City of Ketchum
Planning & Building

STAFF REPORT
KETCHUM PLANNING AND ZONING COMMISSION
MAY 28, 2024 MEETING

PROJECT: 490 Wood River Dr Residence

REQUEST: Floodplain Development Permit for a new 8,077 square foot residence and modification of wetland areas.

SHEET 1 OF 6
L-1.00

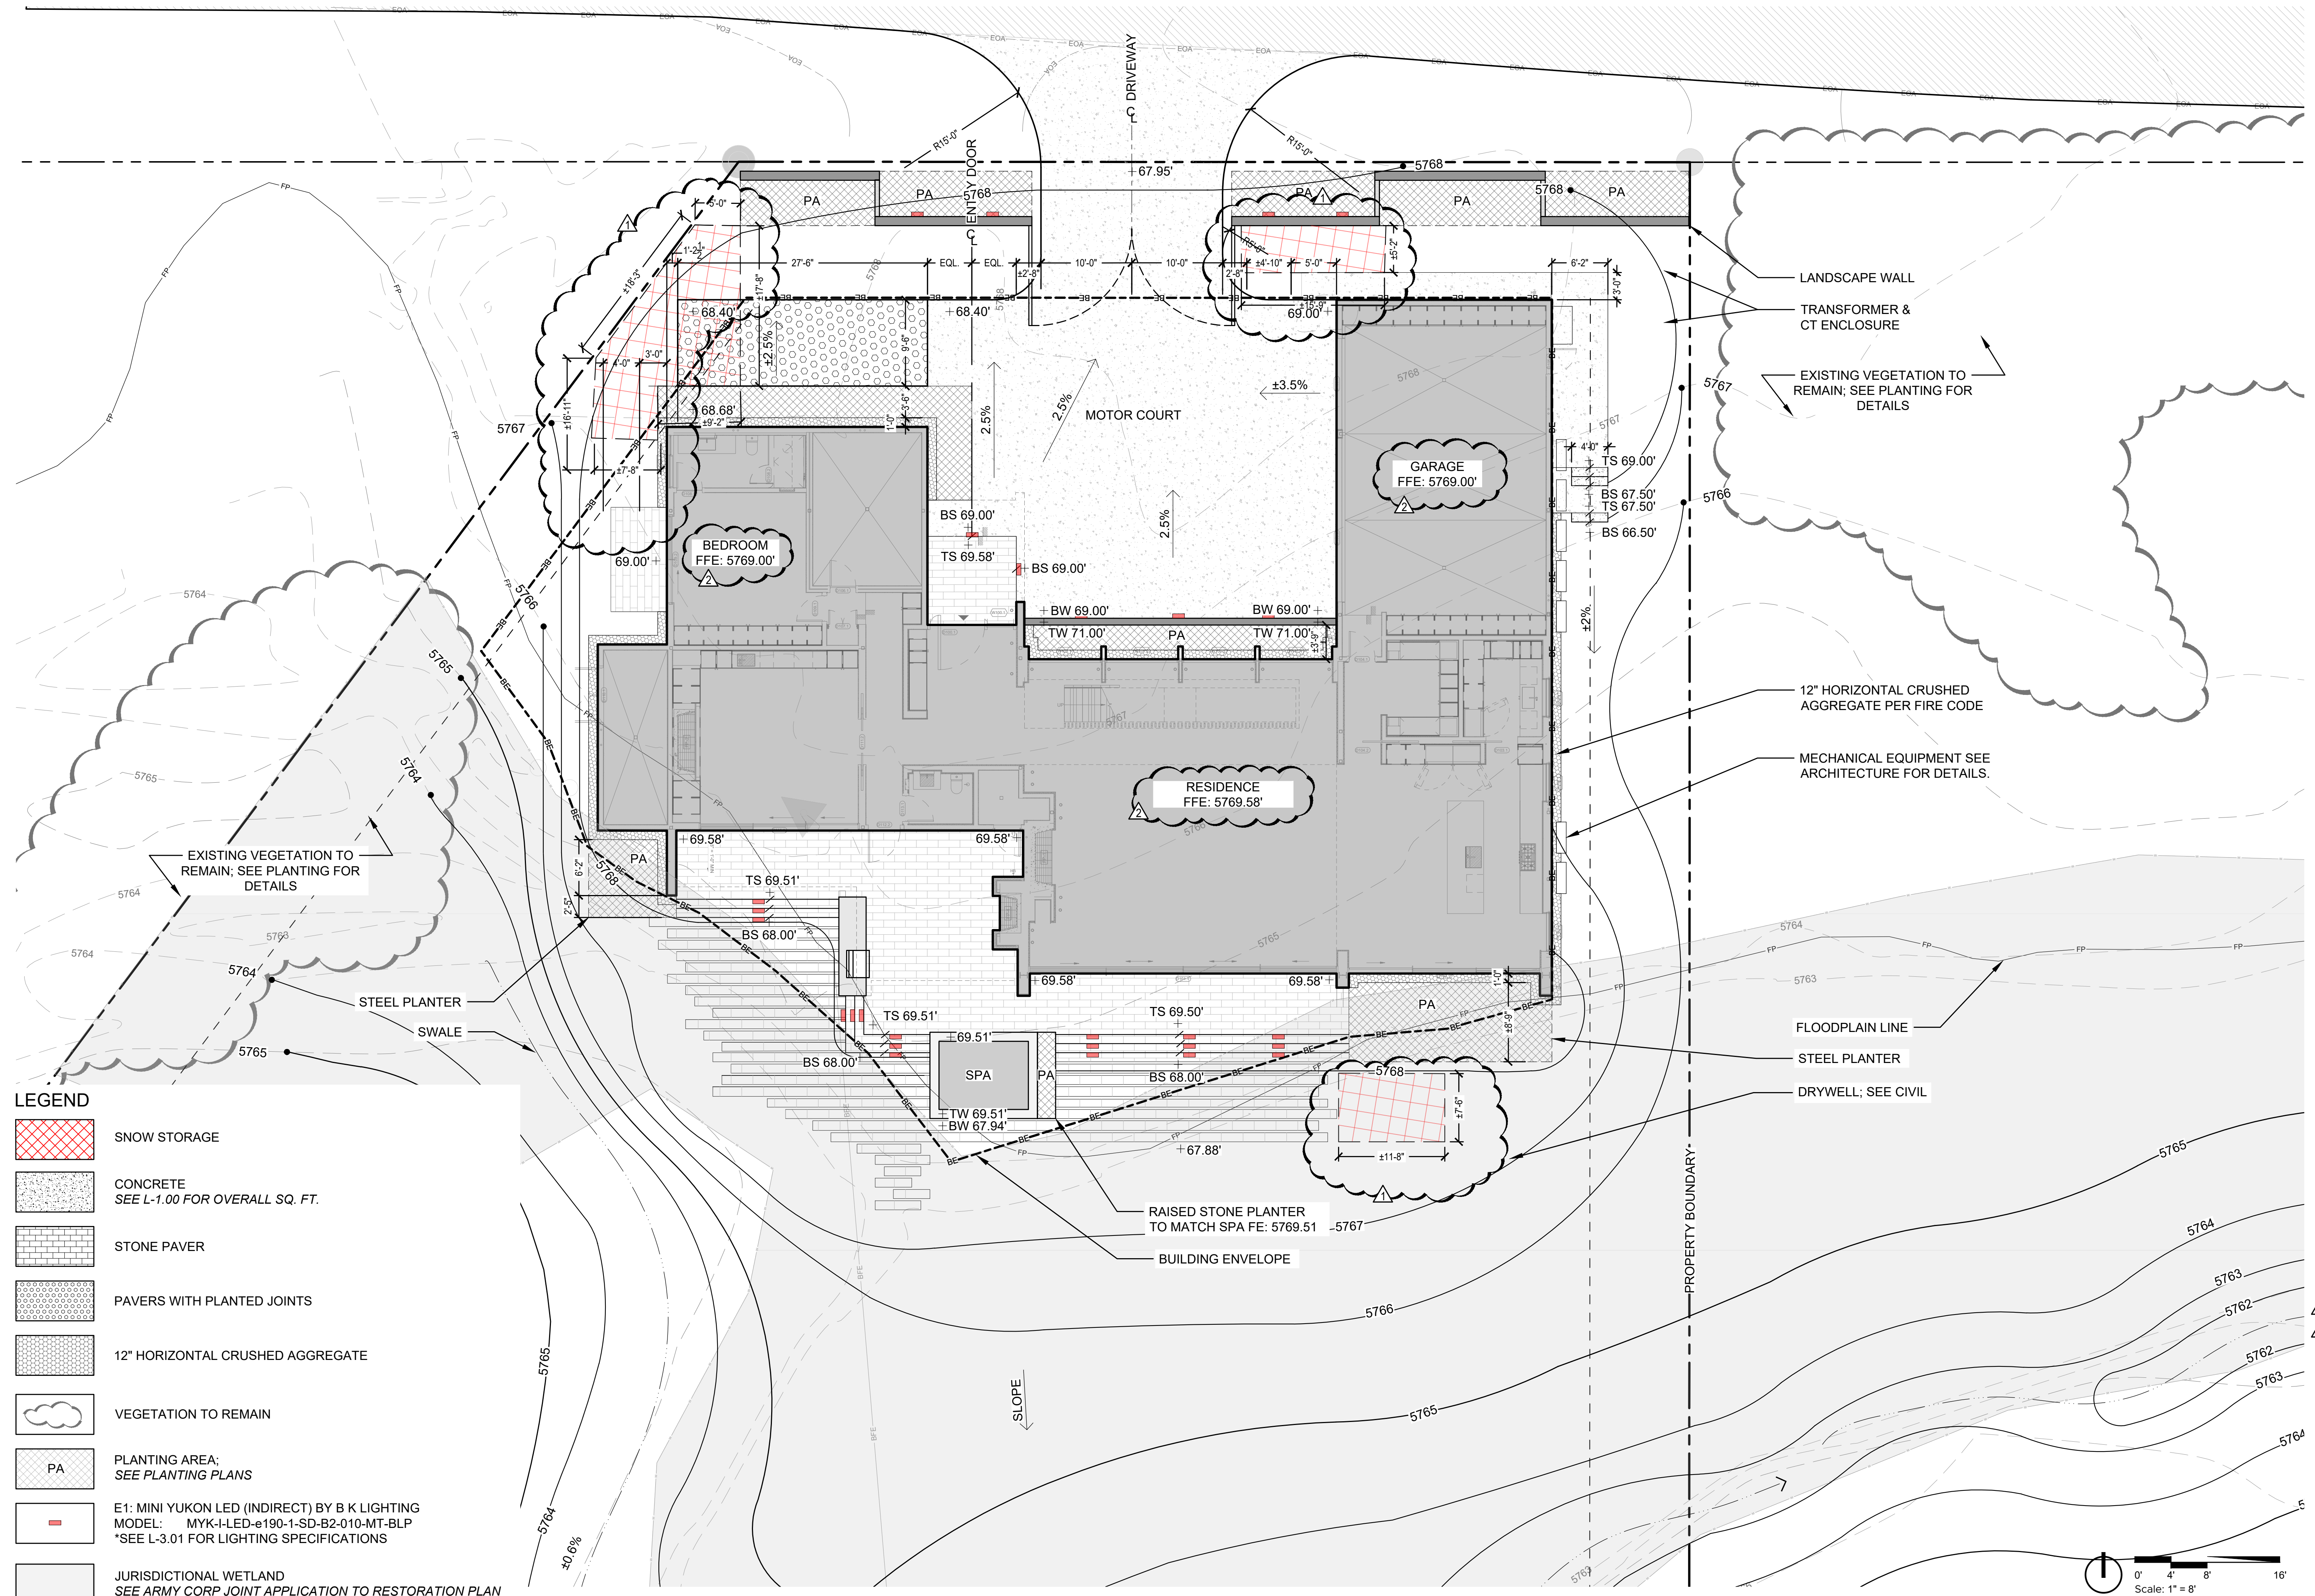
<p>Proposed:</p> <ol style="list-style-type: none">1. As shown on Sheet L-1.00, 4,067 square feet of driveway and pedestrian circulation area is proposed. Of this total, 2,840 square feet is proposed to be snowmelted, leaving 1,226 square feet of non snowmelted area. The required amount of snow storage is 368 square feet and the applicant has proposed 400 square feet.2. Proposed snow storage is located on subject property.3. All snow storage areas do not dimensions less than 5 feet and have an area greater than 25 square feet4. As stated in standard #1, snowmelt is proposed for 2,840 square feet of the proposed driveway & pedestrian circulation area, resulting in 1,226 square feet of non snowmelted area.
--	--	--	--	----------------------------------------------------------------------------------------------------------------------------------------------------------------------------------------------------------------------------------------------------------------------------------------------------------------------------------------------------------------------------------------------------------------------------------------------------------------------------------------------------------------------------------------------------------------------------------------------------------------------------------------------------------------------------------------------------------------------------------------------------------------------------------------
